# UNITED STATES PATENT AND TRADEMARK OFFICE

10/574,741

Otto Bosse

<b>Office Action Summary</b>	<b>Application No.</b> 10/574,741	<b>Applicant(s)</b> BOSSE ET AL.	
	<b>Examiner</b> Nahid Amiri	<b>Art Unit</b> 3679

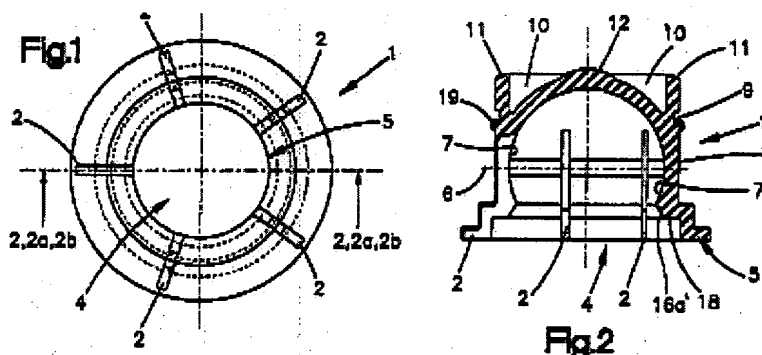
With respect to claims 14-17, Wenzel et al. disclose a ball socket (1, Figs. 1-2, column 5, lines 30-31) for receiving a ball (not shown) comprising at least one elastically deformable region (2); wherein the elastically deformable region (2) is formed of an elastically deformable material; wherein the elastically deformable region (2) includes an elastically deformable geometry; and wherein the ball socket (1) is adapted to cover a ball portion of the ball, the ball portion delimited by at least one circle.

With respect to claim 27, Wenzel et al. disclose a system (Figs. 1-2, column 5, lines 30-31) comprising a rotatably mounted connection arrangement “adapted” to connect a first part (constituted by a ball not shown) to a second part (constituted by a socket 1), the first part

(constituted by a ball not shown) including ball as a connection element, the second part including a ball socket (1) as a connection element and adapted to receive the ball, the second part (1) including at least one elastically deformable region (2). Note that the connection arrangement is the two parts to be connected as is apparently intended to be the case from a reading of claim 27.

With respect to claims 19 and 20, Wenzel et al. disclose (Figs. 1-2) that the ball socket (1) includes at least one gap; wherein the gap is oriented perpendicular to at least one circle that delimits a ball portion of the ball that is covered by the ball socket (1).

With respect to claims 24 and 26, Wenzel et al. disclose (Figs. 1-2) that the elastically deformable region (2) is arranged between a first portion of the circle and a second portion of the circle; and wherein the elastically deformable region (2) includes a thin-walled region.

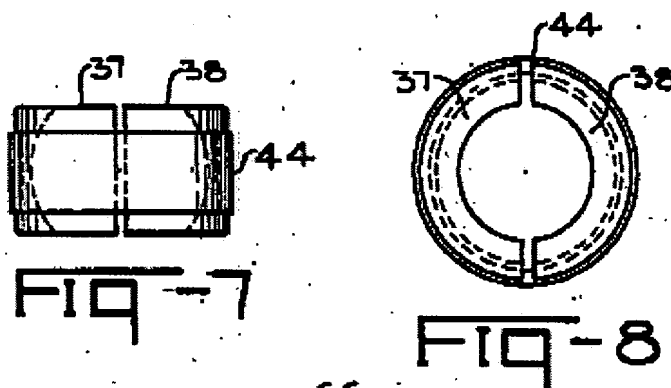
With respect to claims 14-20 and 22-26, Flumerfelt discloses a ball socket (37, 38, 44, Figs. 7 and 8; page 2, column 2, lines 25-27) for receiving a ball (30) comprising at least one elastically deformable region (entire material of 44 is yieldable, but note especially that portion in gaps between 37, 38); wherein the elastically deformable region is formed of an elastically deformable material; wherein the elastically deformable region includes an elastically deformable geometry; wherein the ball socket (37, 38, 44) is adapted to cover a ball portion of the ball (30), the ball portion delimited by two circles arranged parallel to one another; the ball

socket (37, 38, 44) arranged as a ball layer; the ball socket (1) including two gaps; wherein the gaps are oriented perpendicular to the circles that delimit the ball portion of the ball (30) that is covered by the ball socket (1); wherein the elastically deformable region is arranged in one of the two gaps; wherein the at least one gap includes two gaps, wherein the gaps are diagonally arranged to same extends as applicants' gaps are along a circumference of the ball (30); wherein the elastically deformable region is arranged between a first portion of the circle and a second portion of the circle; and wherein the elastically deformable region (D) includes a thin-walled region.

With respect to claims 27, Flumerfelt discloses a system (Figs. 7-8) comprising a rotatably mounted connection arrangement adapted to connect a first part (30) to a second part (44), the first part including ball as a connection element, the second part including a ball socket (1) as a connection element and adapted to receive the ball, the second part (1) including at least one elastically deformable region. Note that the connection arrangement is the two parts to be connected as is apparently intended to be the case from a reading of claim 24.

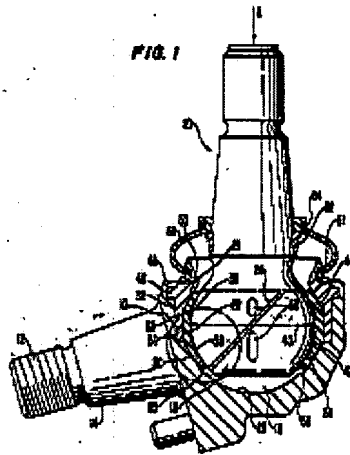
With respect to claims 14, 19 and 21, Zivkovic teaches a ball socket (10, Fig. 1) comprising at least one elastically deformable region (22); at least one gap (constituted by an open end of the socket 10); and wherein the elastically deformable region (22) is arranged as an elongate portion arranged diagonally with respect to the gap.
